Model	PS140 / 250	Volt/Hz	Date of Modification	Serial Number
Modified Article	Parts catalog			
Reason for Modification	Parts catalog correction

MODIFICATION BULLETIN NO. 7

Model: Paper Tray Unit for A7/N440 Date: 31-Jul-98 No.: 9

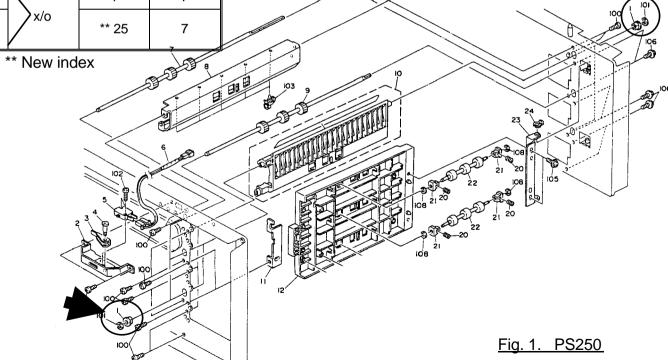
_			ON BULL	EIIIIIIO.	- Tage Tore	<u>, </u>	IBBUED OILL	september 13, 7
Мо	odel	PS140/250						Volt/Hz	Date of Modification	Serial Number
Modifie	d Article	Bushing								
	ication		o reduce mechanical load to main motor							
To reduce	mechanic	al load to main moto	or, the follow	wing bush	ings have t	oeen modi	ied.			
0115/1	N 5/N	6	011 11 1	Inter-	Parts C	Catalog				_
Old P/N	New P/N	Description	Q'ty Used	change- ability	Index No.	Page				•
50530223	7	Bushing - 8mm	6 → 0		1	7		^

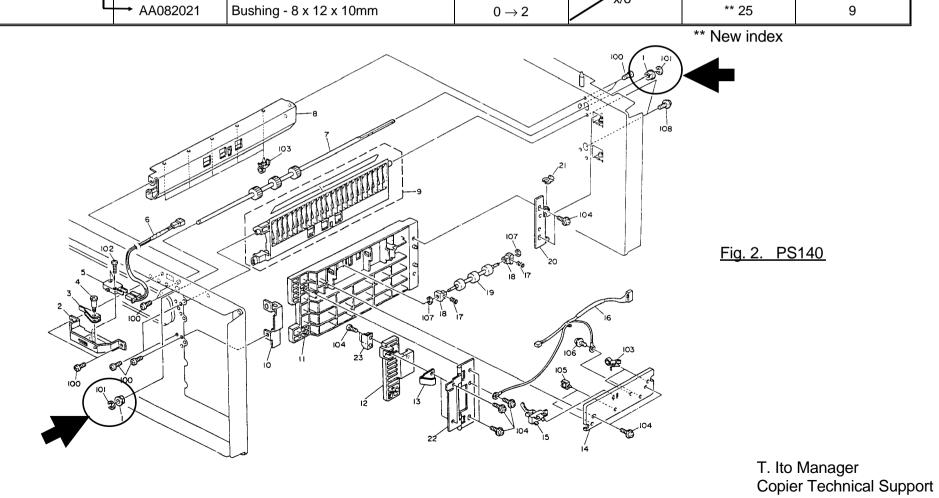
Old P/N	New P/N	Description	O'ty	Interchangeability	Parts 0	Catalog
Olu P/IN	New F/IN	Description	Q'ty	Interchangeability	Index No.	Page
50530223		Bushing - 8mm	$2 \rightarrow 0$	×/0	1	9

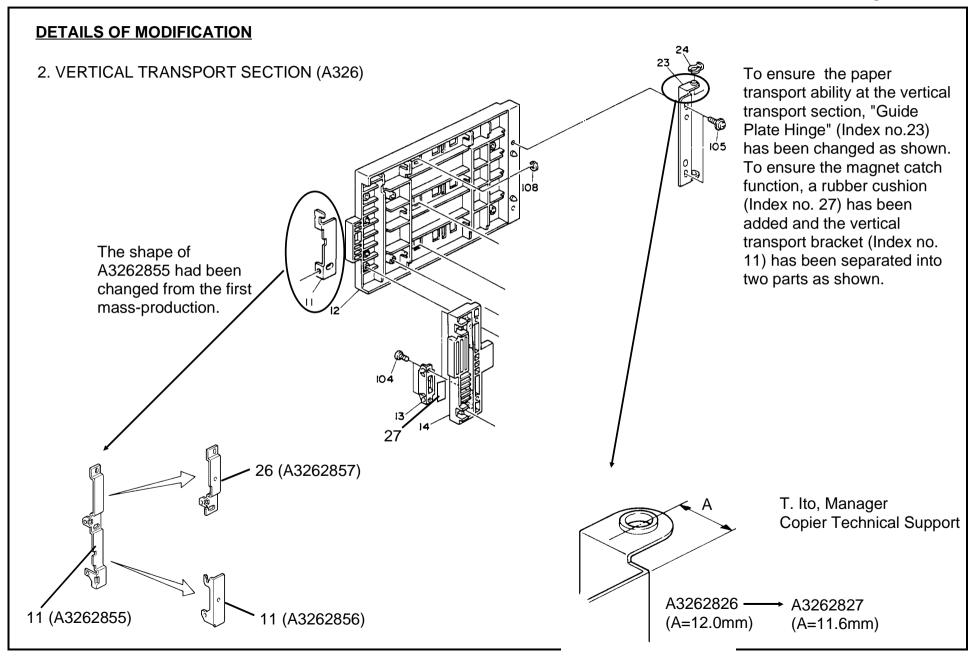
Model		Paper Tray I	Unit for A7 / N440	Volt/Hz	Volt/Hz Date of Modification		Serial Number				
Мо	odified Article	9	Vertical Trar	nsport Bracket / Guide Plate Hin	ge							
	Reason for Modification		To ensure fu	unction of magnet catch on guide								
Draw	Old Parts		New Parts	Description	Rank	Q'ty Used	Q'ty Used change-		d for replaceme	ent by new part	Parts Catalog	
No.	No.		No.	Description	Kank	Old→New	ability	Part No.	Desc	ription	No.	Page
	A3262826		A3262827	Guide Plate Hinge		1 → 1	X/O				23	7
	A3262855 -			Vertical Transport Bracket		1 → 0	X/				11	7
			- A3262856	Vertical Transport Bracket - Small		0 → 1	/X	X/O 8	as a set		11	7
		L	- A3262857	Vertical Transport Bracket - Large		0 → 1	/X				26	7
			A0092667	Cushion - Exposure Glass		0 → 1					27	7

2. VERTICAL TRANSPORT SECTION

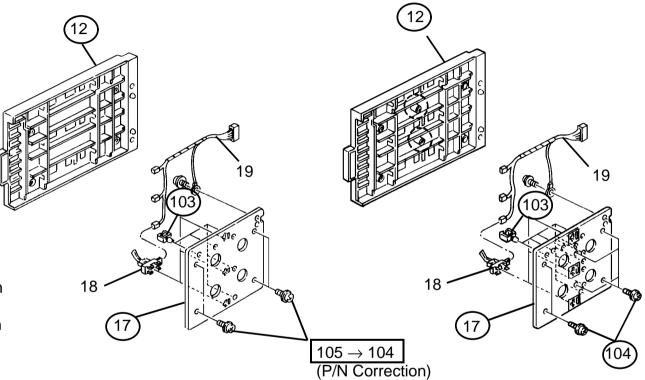
If the vertical transport guide plate (#12) warps, there is a slight possibility that tray relay sensors (#18) may chatter, causing paper jams. To prevent the vertical transport guide plate from warping, the number of screws fixing the guide plate on the sensor bracket (#17) has been increased from 4 to 6. To prevent the harness (#19) from being pinched by the screws, the number of clamp (#103) on the bracket has also been increased from 5 to 9.

The index number of the screws for the sensor bracket should not have been 105 but 104.

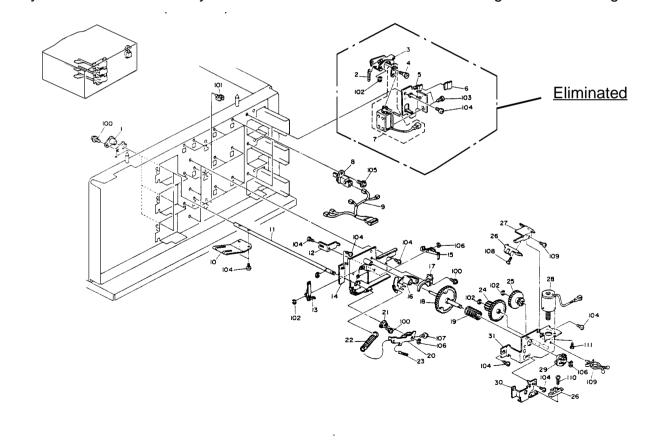
Index No.	Incorrect P/N	Description	Q'ty per Assembly
2	AA060436	Tray Lock Spring	3 (1) → 0
3	A0692837	Tray Lock Lever	3 (1) → 0
4	AA143062	Shoulder Screw - M4	3 (1) → 0
5	A3262773	Bracket - Tray Lock Solenoid	3 (1) → 0
6	A0692834	Sheet Slide	3 (1) → 0
7	A0692773	Tray Lock Solenoid	3 (1) → 0

As it is considered that customers seldom or never pull out the paper tray being used during copy jobs, the tray lock solenoid assembly has been eliminated to facilitate servicing and assembling.

Belt Tightener - Main Drive

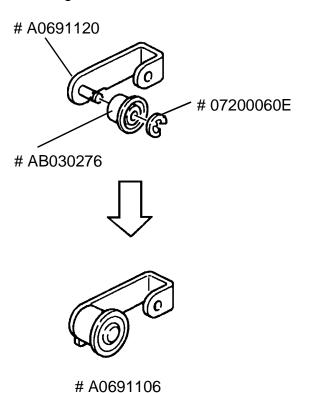
To standardize the belt tightener with copier, the belt tightener has been changed as shown.

2. VERTICAL TRANSPORT SECTION

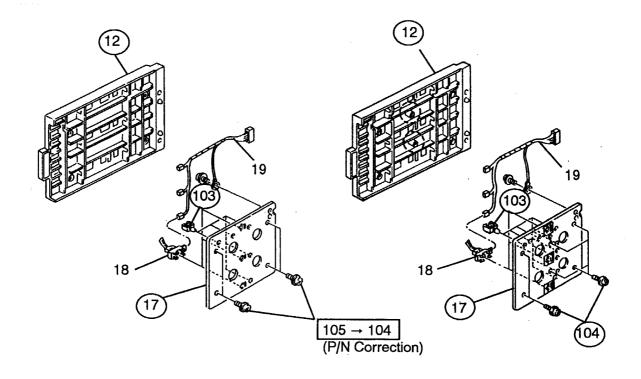
If the vertical transport guide plate (#12) warps, there is a slight possibility that the tray relay sensors (#18) may chatter, causing paper jams. To prevent the vertical transport guide plate from warping, the number of screws securing the guide plate to the sensor bracket (#17) has been increased from 4 to 6. To prevent the harness (#19) from being pinched by the screws, the number of clamps (#103) on the bracket has also been increased from 5 to 9.

The index number of the screws for the sensor bracket should not have been 105 but 104.

The old guide plate-vertical transport (P/N A3262825) is no longer produced. When installing the new guide plate (P/N A3262823) on the old machine, replace the sensor bracket with the new type (P/N A3262828) at the same time.
